MIL-P-63223A (AR)
AMENDMENT 2
12 JULY 1989
SUPERSEDING
AMENDMENT 1
24 February 1987

MILITARY SPECIFICATION

PROJECTILE, GUIDED, 155MM, M712

Figure 7

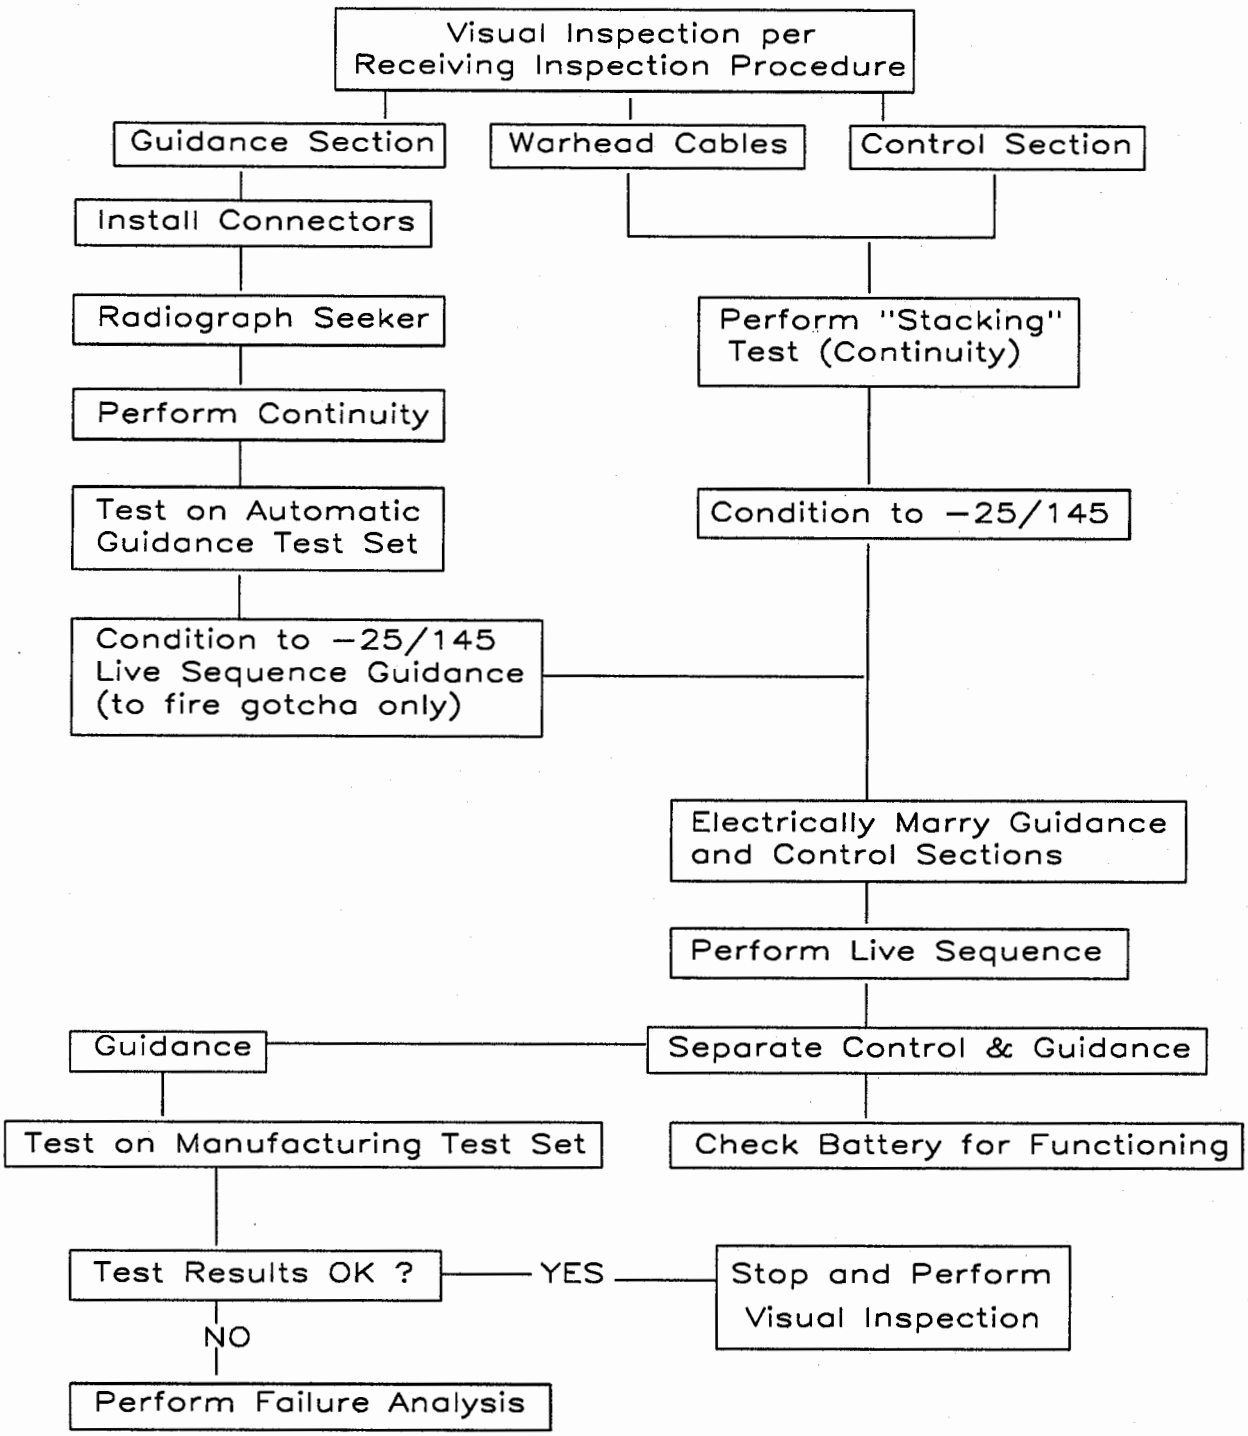
* 4.5.8, Delete line 4 and substitute the following:

"been prepared and soft recovered per 4.5.8.1 and figures 7 and 8. The projectile"

* 4.5.8, Add figures 7 and 8 included.

DECISION TABLE FLOW CHART.

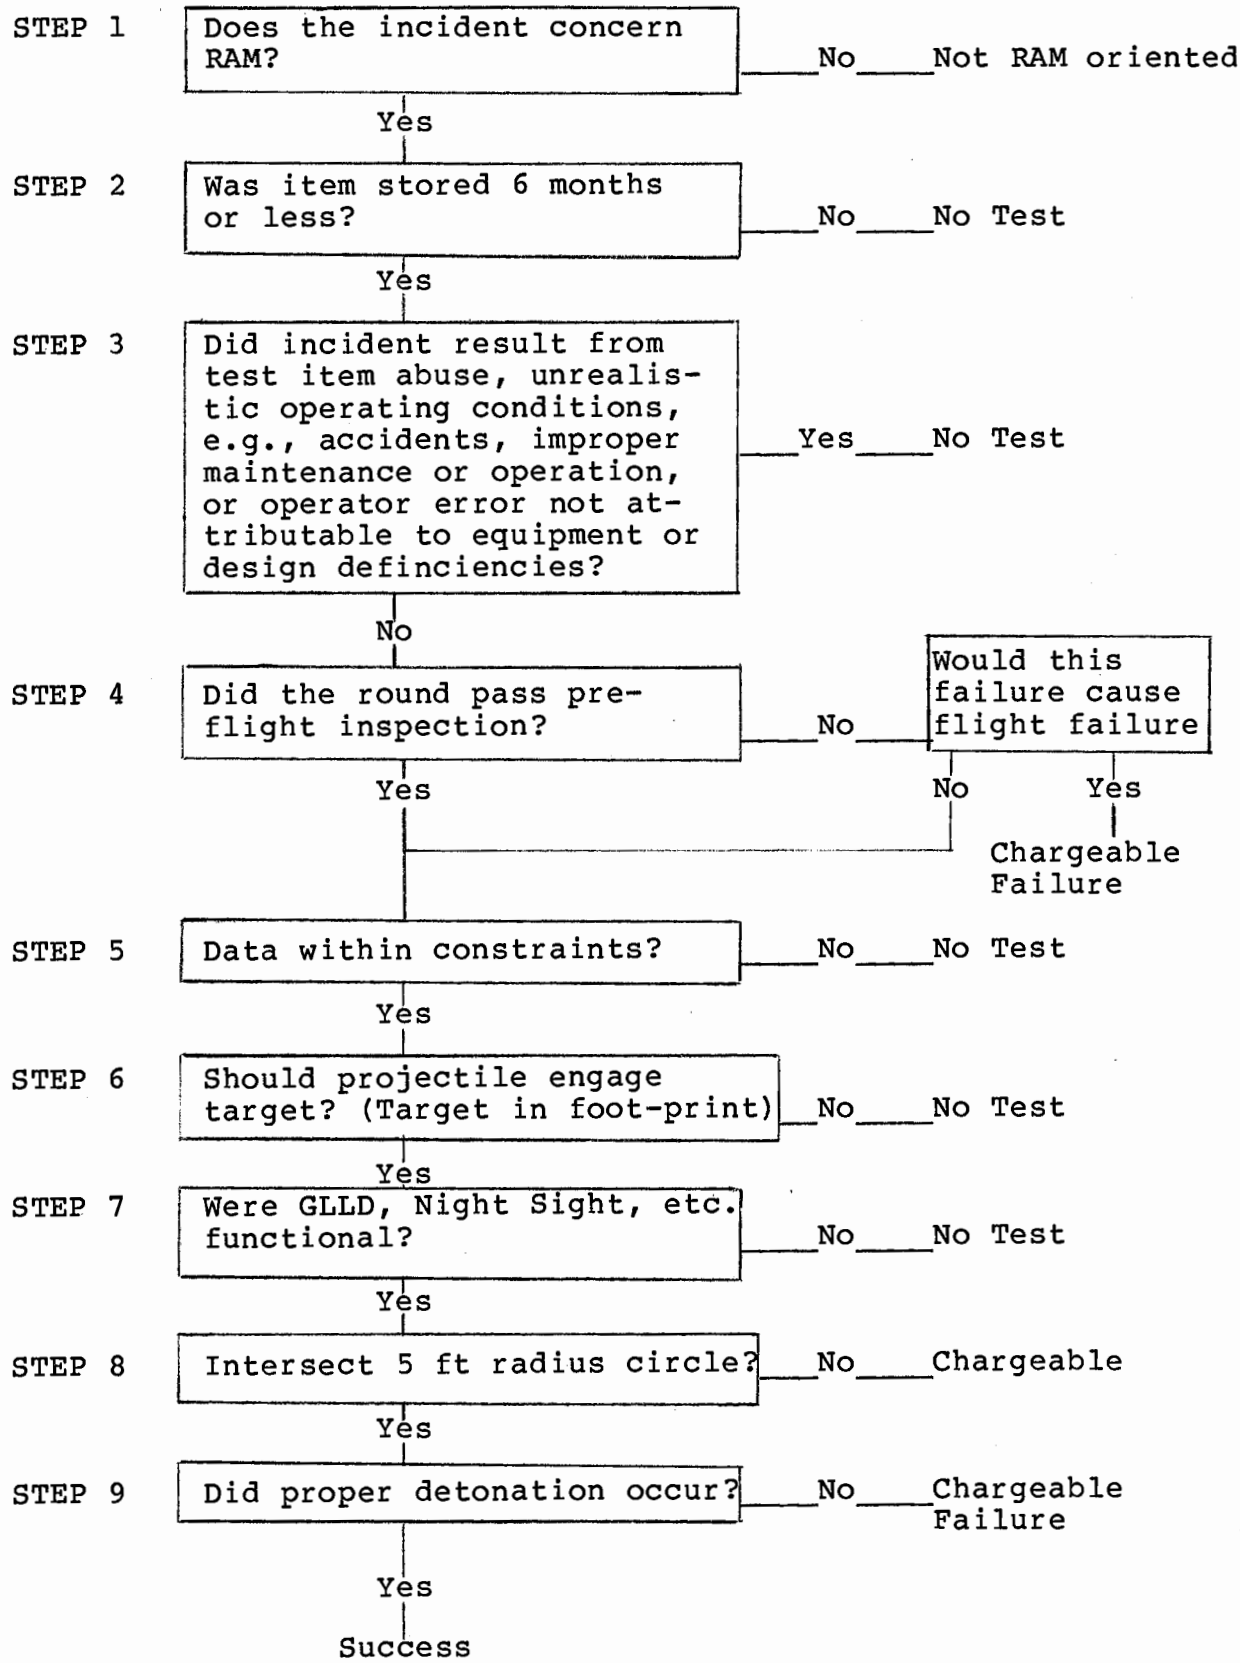
60. Decision table flow chart. The flow chart is shown on the following page."
